## Product Change Notification - SYST-01DHOH680

ERRATA - SAM D21 Family Silicon Errata and Data Sheet Clarification

## SAM D21 Family Silicon Errata and Data Sheet Clarification

The following typographic corrections and clarifications are to be noted for the latest revision of the device Data Sheet (DS40001882D). The corrected information is shown in **BOLD** type.

### 2.3 Schematic Checklist - Crystal Oscillator (Chapter 42 of the Device Data Sheet)

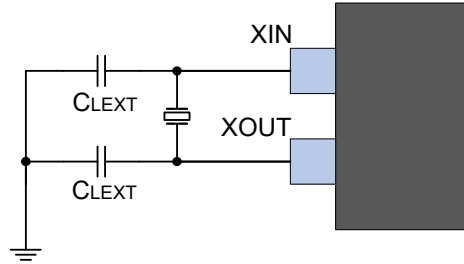
The load capacitor values shown in figure 42-6 and table 42-5 should not be used.  $C_{LEXT}$  should be calculated from the Load Capacitance Equation listed below. The corrected information is shown in **BOLD** type.

Signal Name	Recommended Pin Connection	Description
XIN	Load capacitor $C_{LEXT}^{(1)(2)}$	External crystal between 0.4 to 30 MHz
XOUT	Load capacitor $C_{LEXT}^{(1)(2)}$
